February 28, 2023

Subject: **Review of Plans and Response to Geotechnical Review Comments**
Proposed New Residence
6950 Southeast Maker Street
Mercer Island, Washington

Reference: Geotechnical Engineering Study, same project; Geotech Consultants, Inc.; March 21, 2022.

Cross Section A - A

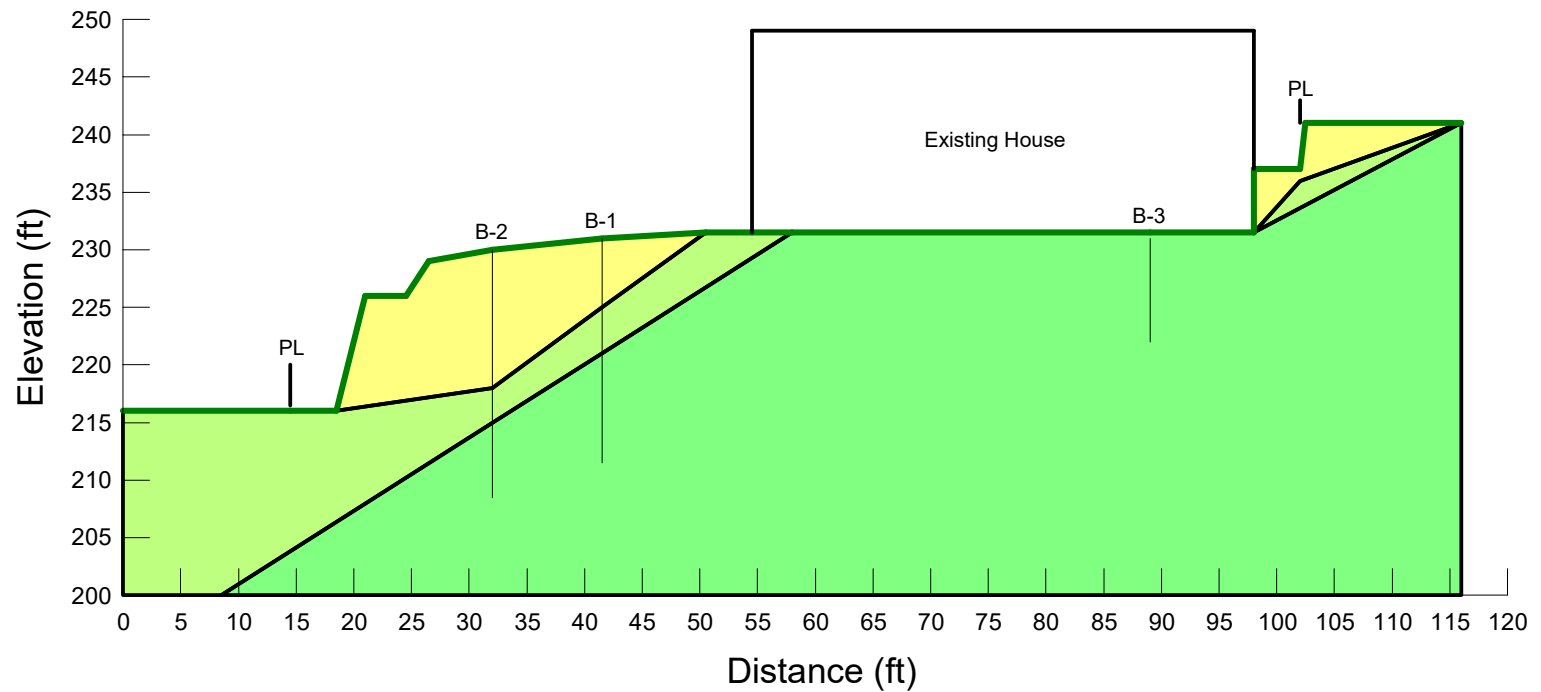
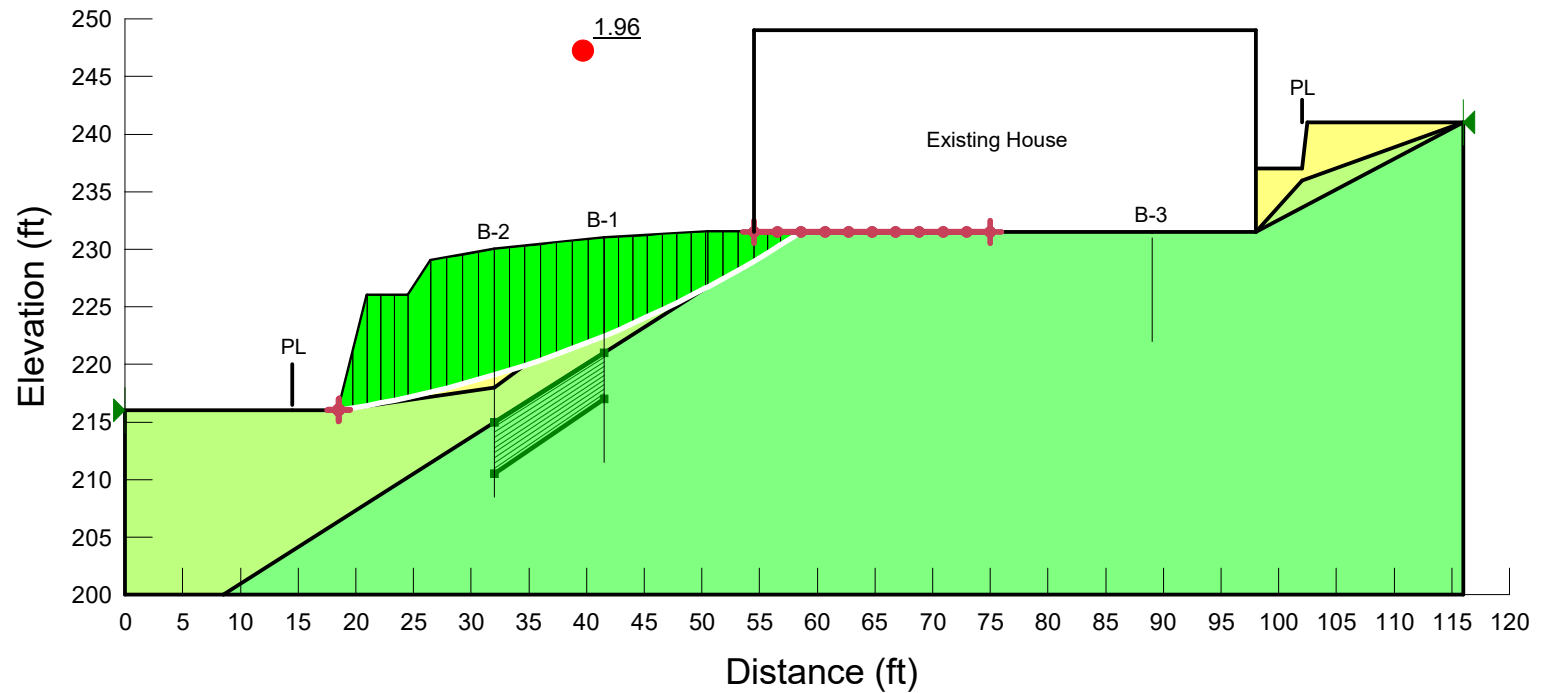
Updated Slope Stability Analyses: Attached to this letter are the results of our slope stability analyses through the residence and the western yard and manmade steep slope. For our analyses, we utilized the peak ground motions of the Maximum Considered Earthquake, which has a probability of occurring once in 2,475-years.

Not surprisingly, the slope stability analyses confirmed that a deep failure would not extend into the competent glacial till underneath the proposed residence in the worst case scenario (during a seismic event). At the western extent of your planned house, which is essentially the same as the west edge of the existing residence, the theoretical critical failure surface would extend only 4.5 feet below the existing grade.

Considering the above discussion, the residence will be protected against being undermined by a theoretical slope failure in the event of the low-probability Maximum Considered Earthquake. No additional mitigation measures are needed to protect your house for the design seismic event.

Seismic

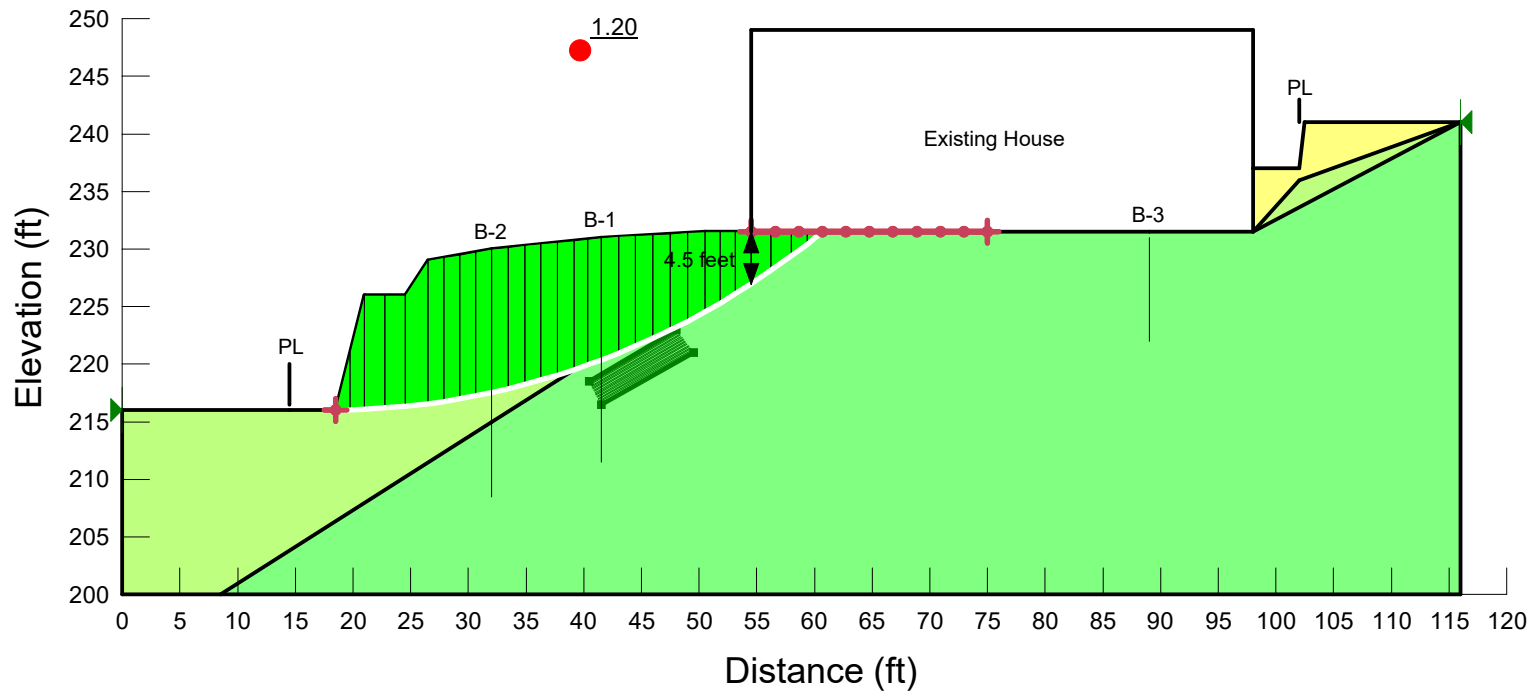
Based on the provided drawings, the basement floor for your new residence has a finish floor elevation of 226.47 feet, which is 4 feet below the existing grade. The western footing for the new house will be bottomed at least 12 inches below the finish floor elevation, based on the Foundation Plan (sheet S2.0) and detail 101/S1.1. As a result, as a minimum, the western footing of the new house will bear below the critical slope stability failure surface. In addition, this footing (as well as the remainder of the house) will bear directly on competent glacial till that is not susceptible to instability.
